STAFF REPORT
COMMUNITY DEVELOPMENT DEPARTMENT

HEARING DATE: 10/6/2022
 TO: Planning & Zoning Commission
 FROM: Joe Dodson, Associate Planner
 208-884-5533
 SUBJECT: H-2022-0050
 Allure Subdivision
 LOCATION: The site is located at 5385 S. Meridian Road, directly north of the half-mile mark on the west side of Meridian Road between E. Amity and E. Lake Hazel Roads, in the SE 1/4 of the NE 1/4 of Section 36, Township 3N, Range 1W.

PP10

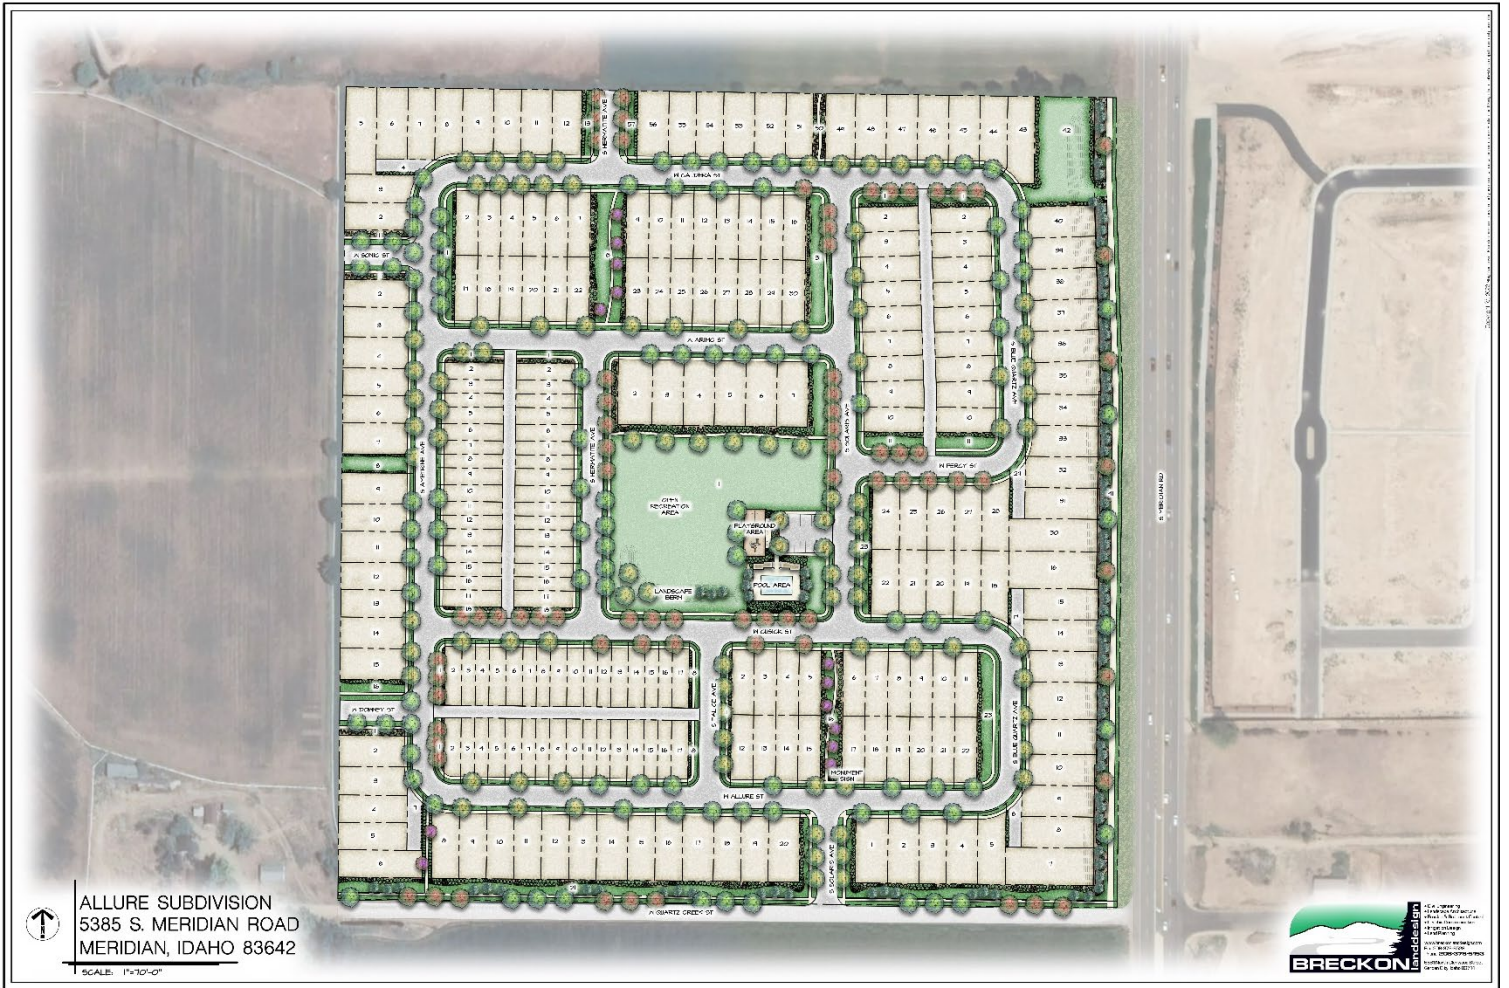
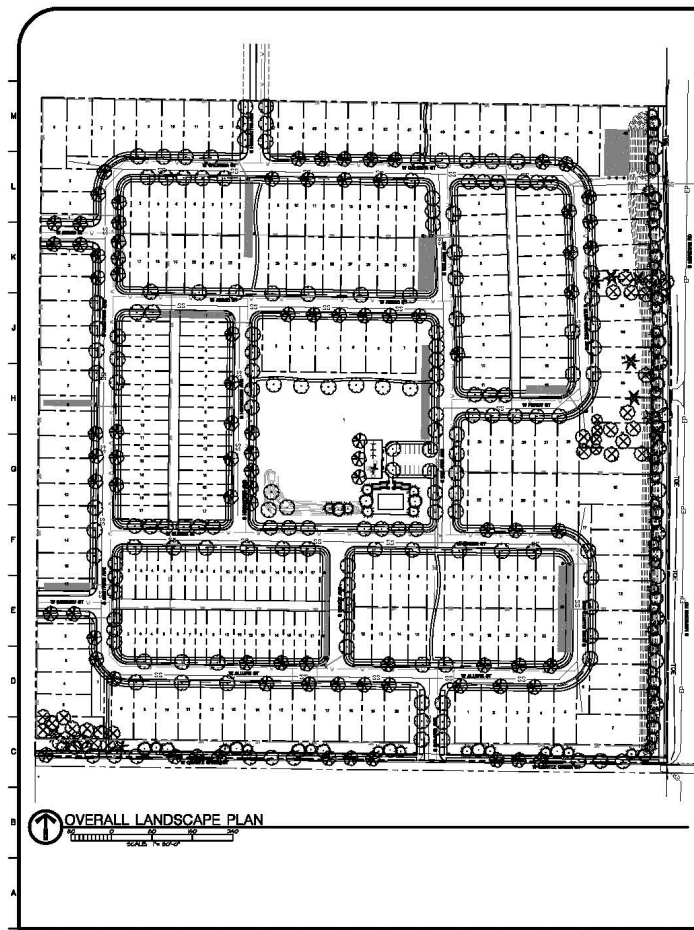
The proposed preliminary plat and submitted plans appear to meet all UDC requirements but the plat should depict the proposed lots that have zero lot-lines (proposed attached and townhome products) to ensure compliance with setback requirements with the future building permit submittals. Therefore, the Applicant should revise the plat to depict the applicable zero lot-lines with each applicable final plat submittal.

2. The preliminary plat included in Section VII.B, dated June 15, 2022, shall be revised as follows with the applicable final plat submittals:
 - a. Revise the plat to show ACHD approved traffic calming along W. Quartz Creek Street, S. Ametrine Avenue, W. Allure Street, W. Cusick Street, S. Solaris Avenue, and W. Caldera Street, coordinate with Meridian Fire and ACHD as necessary.

- b. Depict the required emergency access to Meridian Road/SH 69, as approved by the Meridian Fire Department.
 - c. With each applicable final plat submittal, revise the plat to depict any proposed zero lot-lines for the single-family attached and single-family townhome dwellings.

- d. Add a plat note stating that direct lot access to S. Meridian Road/SH 69 and W. Quartz Creek Street is prohibited.
3. The landscape plan included in Section VII.C, dated June 15, 2022, shall be revised as follows prior to the City Council hearing:

SHEET NUMBER L10

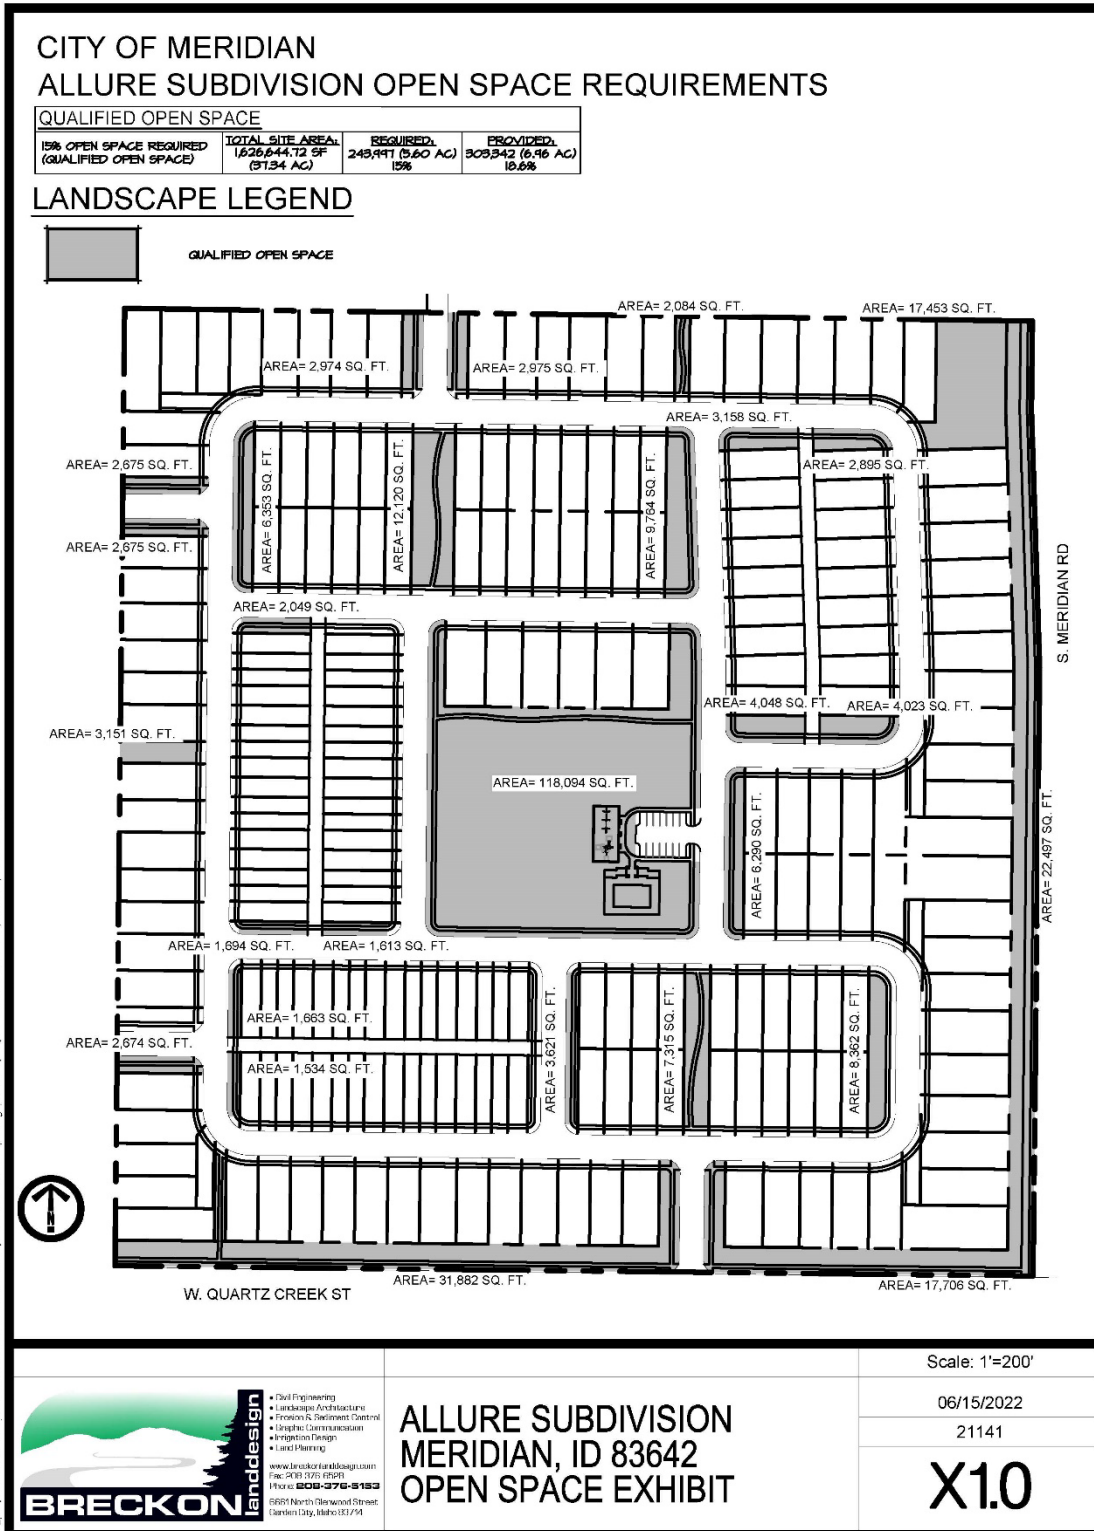
the TN-R zoning district. Parkways are required to be vegetated with an average of 1 tree per every 35 linear feet to be compliant. The submitted landscape plan appears to show compliance with this requirement but the calculations table does not note the linear feet of parkways along the interior local streets and the required number of trees; the Applicant should correct this with the Final Plat submittals to ensure compliance with this requirement.

All fencing is required to comply with the standards listed in UDC 11-3A-7. Fencing is proposed as shown on the landscape plan and appears to meet UDC standards as proposed except for the lack of fencing noted adjacent to the common drives and the 6-foot open vision fencing proposed adjacent to three micro-path lots (Lot 21, Block 2, Lot 16, Block 3, & Lot 8 Block 10).

The submitted landscape plans do not depict any fencing adjacent to the common drives as required by code for properties that do not take access from the common drive. Therefore, with the future final plat applications, the Applicant should revise the landscape plans to depict the proposed fencing on the required common drive exhibit.

- a. Revise the landscape plan to match the plat revision noted in VIII.A2 above.
 - b. Depict the required berm/wall combination along Meridian Road to extend to the north property line to minimize the breaks in the wall.

- c. In the landscape calculations table, show the linear feet of parkways and include the required number of trees and proposed number of trees in accord with UDC 11-3B-7C.

- d. Revise the fencing adjacent to three micro-path lots (Lot 21, Block 2, Lot 16, Block 3, & Lot 8 Block 10) to be 6-foot privacy fencing.
 - e. With the future final plat applications, depict the proposed fencing adjacent to the proposed common drives.

ALLURE SUBDIVISION MERIDIAN, ID 83642 OPEN SPACE EXHIBIT

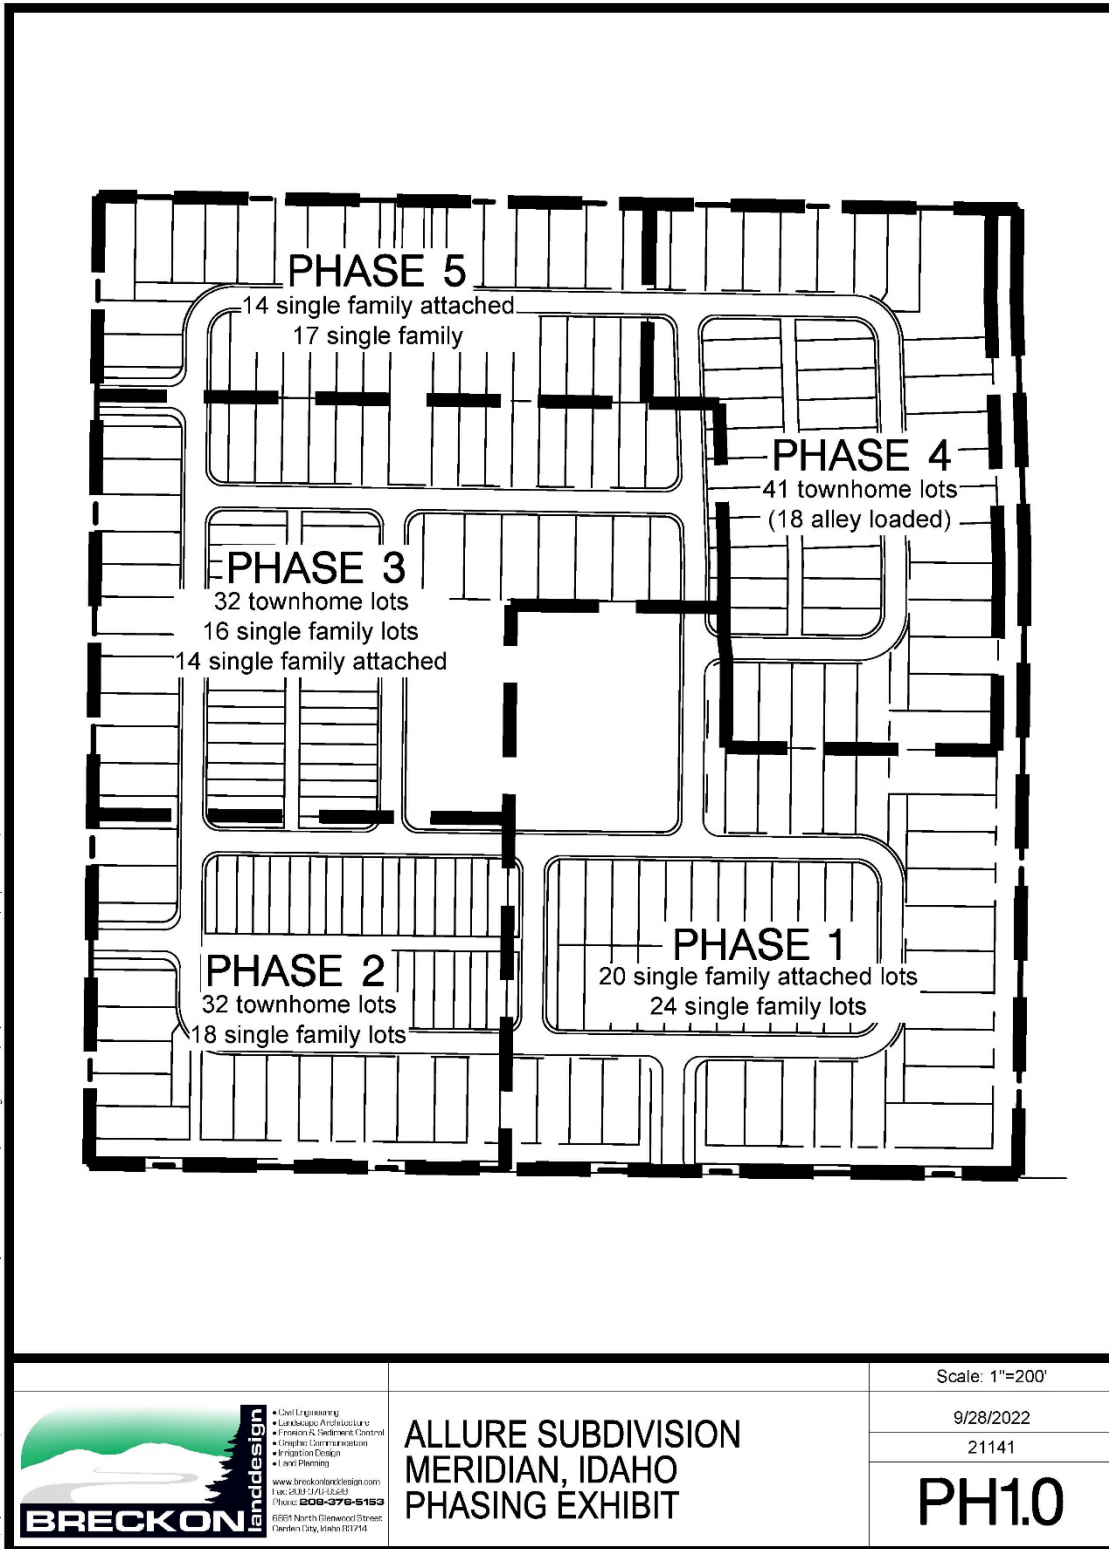
The Applicant's open space exhibit (Section VII.D) shows 6.96 acres of qualified open space (approximately 18.6%), exceeding the minimum required amount of 5.6 acres. However, some of the areas noted on the exhibit as qualifying do not qualify per UDC 11-3G-3 standards because they are not at least 20 feet in width. Staff does not recommend these areas be revised to add an additional few feet as they are already remnant pieces along end-caps of housing blocks that do not entirely meet the intent of the open space code. Further, the removal of these areas is nominal and will not affect the Applicant's compliance with the minimum open space requirements. It is important to note the Applicant's qualified open space calculation does not include any of the parkways within the development which is qualifying open space if the correct number of trees are added to the parkways. Therefore, the actual proposed qualified open space vastly exceeds the minimum amount required by code. The Applicant does not need to use this area as qualified open space to meet the minimum 15% amount and parkways are already required as part of the site design for the requested TN-R zoning district. So, Staff is not concerned the open space exhibit does not show this area but would recommend this area is added to the exhibit to ensure a fully accurate open space calculation is depicted in the record. ***This revision should occur prior***

- 5. Prior to the City Council hearing, the Applicant shall submit a revised Open Space Exhibit depicting the qualifying parkways throughout the development.**
